<h2>Product / Process Change Notification (PCN)</h2>	
<input type="checkbox"/> Major Change <input checked="" type="checkbox"/> Minor Change	
<b>PCN Number:</b> PCN_WSEN-ITDS_20241120  <b>Affected Series:</b> WSEN-ITDS  <b>Affected Order Codes:</b> 2533020201601, 25330202016011  <b>PCN Date:</b> 2024-08-20 (YYYY-MM-DD) <b>Effective Date:</b> 2024-11-20 (YYYY-MM-DD)	<b>Change Category:</b> <input type="checkbox"/> Equipment/Location <input checked="" type="checkbox"/> General Data <input type="checkbox"/> Material <input type="checkbox"/> Process <input type="checkbox"/> Product Design <input type="checkbox"/> Shipping/Packaging <input type="checkbox"/> Supplier <input type="checkbox"/> Software
<b>Contact:</b> Product Management <b>Phone:</b> +49 (0) 7942 - 945 5001 <b>Fax:</b> +49 (0) 7942 - 945 5179 <b>E-Mail:</b> pcn.eisos@we-online.com	<b>Datasheet Change:</b> <input checked="" type="checkbox"/> Yes <input type="checkbox"/> No  <b>Attachment:</b> <input type="checkbox"/> Yes <input checked="" type="checkbox"/> No

*Change in figure showing the sensing axes of the sensor:*

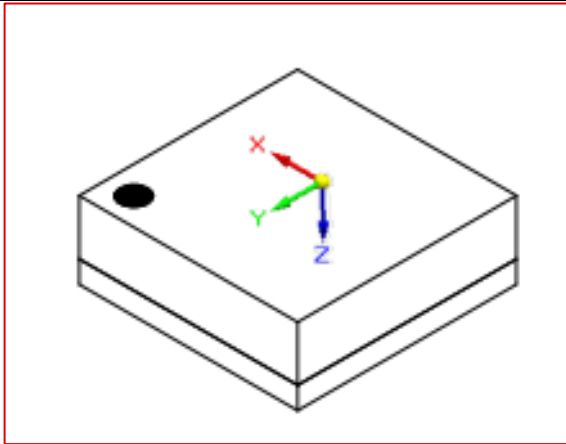
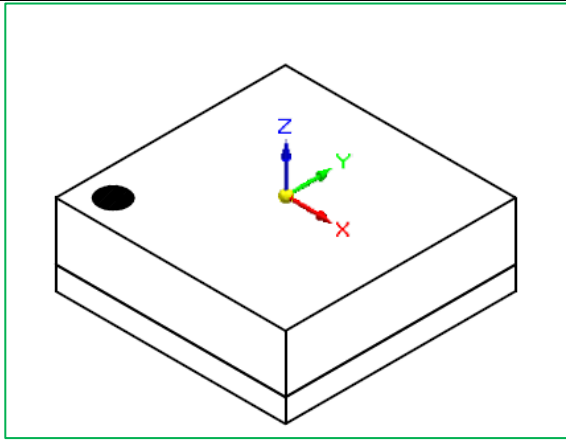
<b>Description of Change:</b>  <p>As a datasheet information amendment, Würth Elektronik eiSos will update the following:</p> <ul style="list-style-type: none"> <li>Figure showing the sensing axes of the sensor is corrected.</li> <li>Footnote No:2 of the table "Acceleration Sensor Specification".</li> </ul> <p>This is a datasheet correction only. There will be no change in form, fit, function, quality or reliability of the product.</p>

Before Change	After Change
